Access Compliance Report

Public Rights-of-Way (Curb Ramps)

Intersection ID: 10040584		Main Street: W_ARROWWOOD_RD		Cross Street: N/A		Location:		SW	
ADA ID: 5321F5F1864D		Ramp Type: Directional1		Initial Pass/Fail: Pass		Overall Compliance: No		Severity Score: 2.5	
Codes/Mitigation Info/Possible Solution				Field Measurements/Component Compliance					
 Possible Solutions: Remove & Replace Entire Ramp. Remove & Replace Gutter. Surveyor Notes: N/A PROW/ADA: Not Found, R304.2.2-Perp, R304.3.2-Para, R304.5.2, R305.1.4, R304.5.3 Street 1 NameENTRANCE Stop Condition-Street 1StopSign Street 2 NameN/A Stop Condition-Street 2N/A Total Cost:\$2350.00				Compliance	Description	Data	Compliance	Description	Data
				N/A	Ramp Length (in)	21.0	No	Grade Break?	No
				Yes	Ramp Width (in)	60.0	N/A	Grade Break Slope (%)	2.1
				Yes	Ramp Slope (%)	6.6	N/A	Grade Break XSlope (%)	3.1
				Yes	Ramp XSlope (%)	1.5			
				N/A	Flare Type LT	N/A	N/A	Flare Type RT	N/A
				N/A	Flare Slope LT (%)	7.4	N/A	Flare Slope RT (%)	5.0

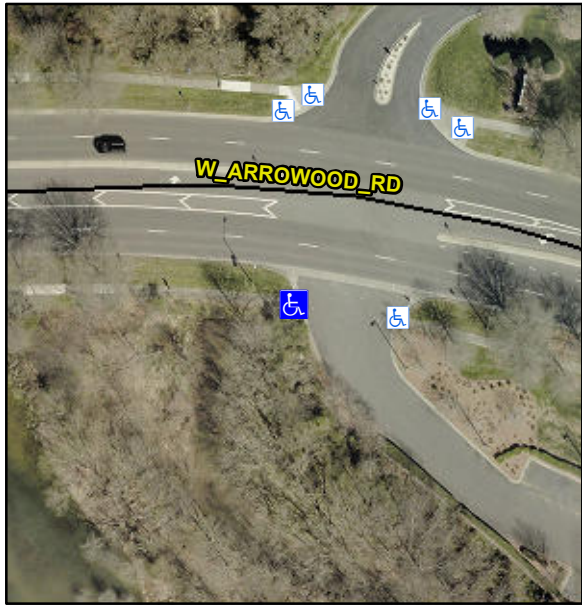
N/A	Flare Traversable LT?	No	N/A	Flare Traversable RT?	No
				Yes	Landing Length (in)	65.0	Yes	DWS Provided?	Yes
				Yes	Landing Width (in)	60.0	Yes	DWS Contrast?	Yes
				No	Landing Slope (%)	3.6	Yes	DWS Length (in)	24.0
				Yes	Landing X Slope (%)	1.2	No	DWS Full Width?	No
				N/A	Landing Curb? (Y/N)	N/A	Yes	DWS Offset LT (in)	0.0
				N/A	Shared Landing?	No	Yes	DWS Offset RT (in)	0.0
				Yes	Gutter Ponding?	No	Yes	Gutter Slope (%)	2.0
				Yes	Gutter Lip Ht (in)	0.0	No	Gutter X Slope (%)	2.2
				N/A	Painted X Walk1?	No		Road Slope (%)	2.4
					X Walk 1 Direction	To NE		Road X Slope (%)	2.1
					X Walk 1 Width (in)	N/A		Clear Space?	Yes
					X Walk 1 Slope (%)	2.4	N/A	Clear Space to XWalk (in)	N/A
					X Walk 1 X Slope (%)	2.1	Yes	Storm Grate/Utility Hazard?	No
				N/A	Ramp inside XWalk1?	N/A		Storm Grate/Utility Type	
				Yes	Any Obstructions?	No			N/A
					Obstruction Type		Yes	Surface Condition? (G/P)	Good

N/A	Curb Slope (%)	18.1
